**PLANNING COMMISSISON  
SITE PLAN WAIVER REQUEST REVIEW SHEET**

**CASE NUMBER:** SP-2010-0181CS      **PLANNING COMMISSION**  
**HEARING DATE:** January 11, 2011

**PROJECT NAME:** Mixed Use Condos at 1415 W 51st Street

**BUILDABLE AREA DIAGRAM**

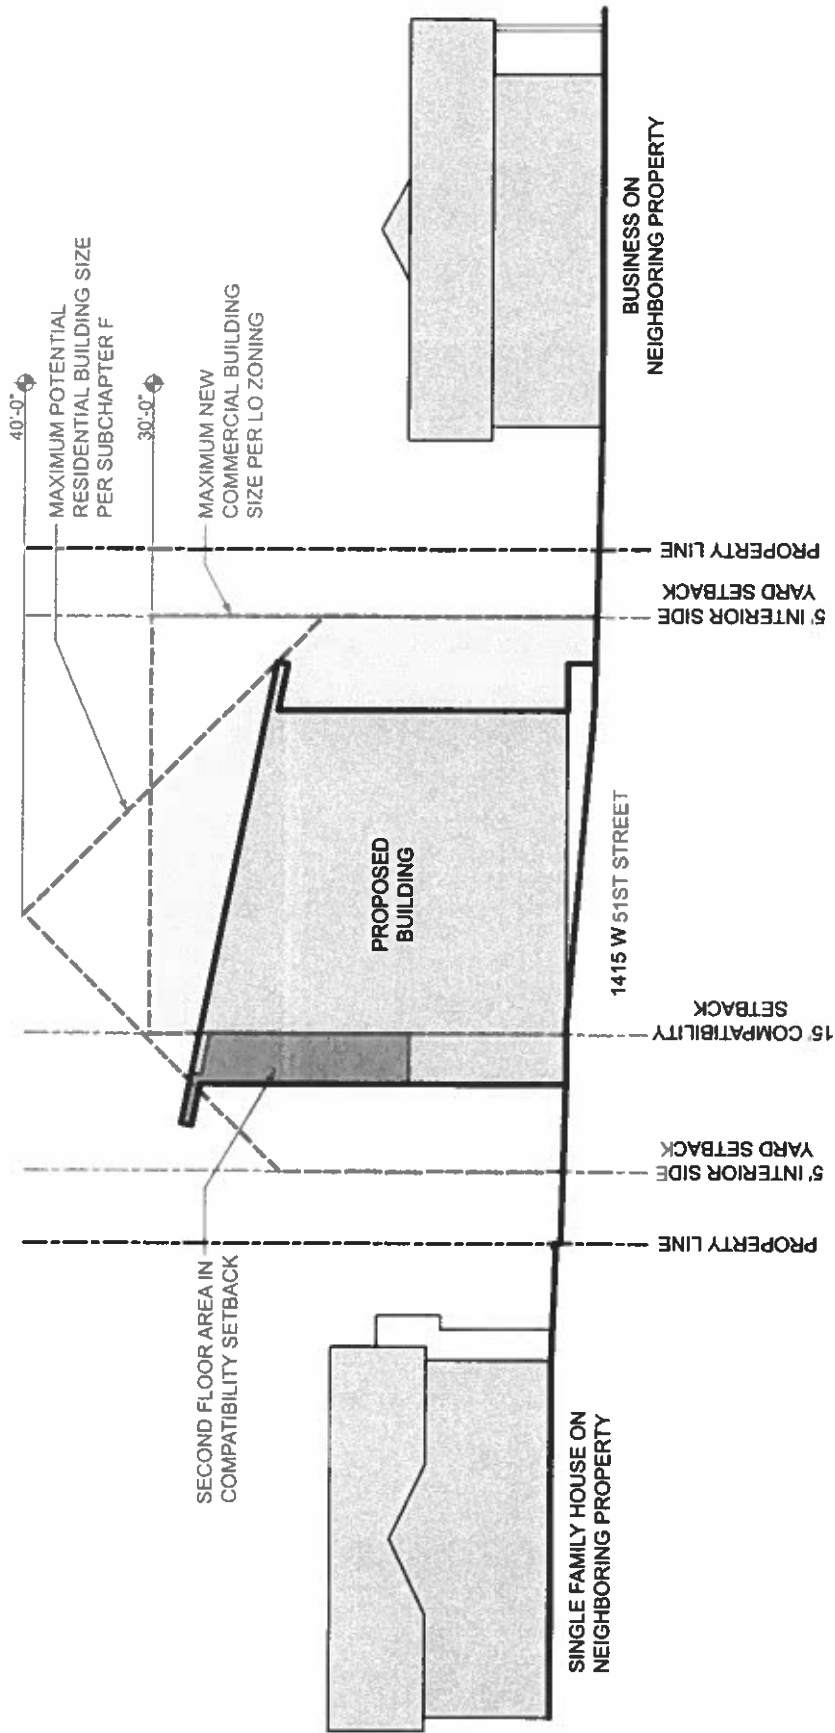
The proposed expansion of the second story of the commercial structure will extend ±3' into the 15' Compatibility Setback, as can be seen on the attached "Buildable Area Diagram". But the structure does not encroach on the neighboring single-family property as much as a proposed residential building could if built to its maximum potential size, which can also be seen on the referenced diagram. Also the proposed front porch of the proposed structure is similar many of the other single family homes on the street and not out of scale with the neighborhood.
